Access Compliance Report

Public Rights-of-Way

Intersection ID: 47965	Main Street: TURNING_HAWK_RD	Cross Street: MESA_VERDE_RD	Location: NW
ADA ID: E763C2DEC299	Ramp Type: PerpDiag	Initial Pass/Fail: Fail	Overall Compliance: No
		Severity Score: 8.75

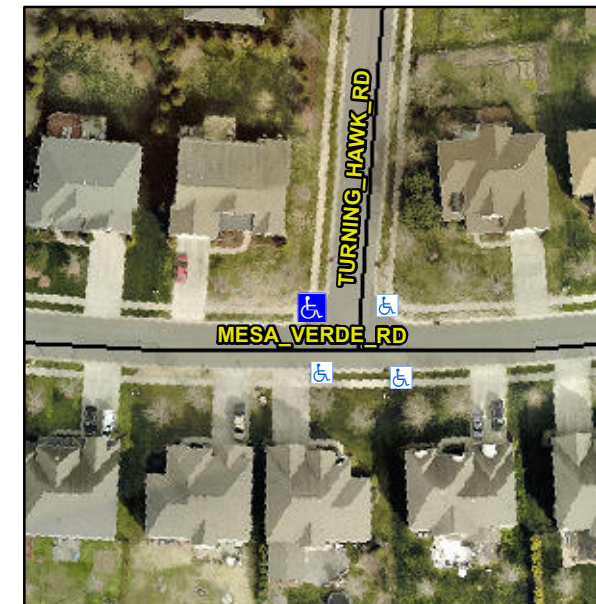
R304.5.1

Compliance	Description	Data	Compliance	Description	Data
N/A	Ramp Length (in)	47.0	Yes	Ramp Slope (%)	7.1
No	Ramp Width (in)	47.0	Yes	Ramp XSlope (%)	0.5
N/A	Flare Type LT	N/A	N/A	Flare Type RT	N/A
N/A	Flare Slope LT (%)	N/A	N/A	Flare Slope RT (%)	N/A
N/A	Flare Traversable LT?	N/A	N/A	Flare Traversable RT?	N/A
N/A	Landing Length (in)	N/A	N/A	DWS Provided?	N/A
N/A	Landing Width (in)	N/A	N/A	DWS Contrast?	N/A
N/A	Landing Slope (%)	N/A	N/A	DWS Length (in)	N/A
N/A	Landing X Slope (%)	N/A	N/A	DWS Full Width?	N/A
N/A	Landing Curb? (Y/N)	N/A	N/A	DWS Offset (in)	N/A
N/A	Shared Landing?	N/A			
N/A	Gutter Ponding?	N/A	N/A	Gutter Slope (%)	N/A
N/A	Gutter Lip Ht (in)	N/A	N/A	Gutter X Slope (%)	N/A
N/A	Painted X Walk1?	No	N/A	Painted X Walk2?	No
	X Walk 1 Direction	To S		X Walk 2 Direction	To E
N/A	X Walk 1 Width (in)	N/A	N/A	X Walk 2 Width (in)	N/A
	X Walk 1 Slope (%)	1.3		X Walk 2 Slope (%)	2.5
	X Walk 1 X Slope (%)	1.5		X Walk 2 X Slope (%)	2.1

Remove & Replace Curb Ramp With Two New Directional Ramps or Equivalent.
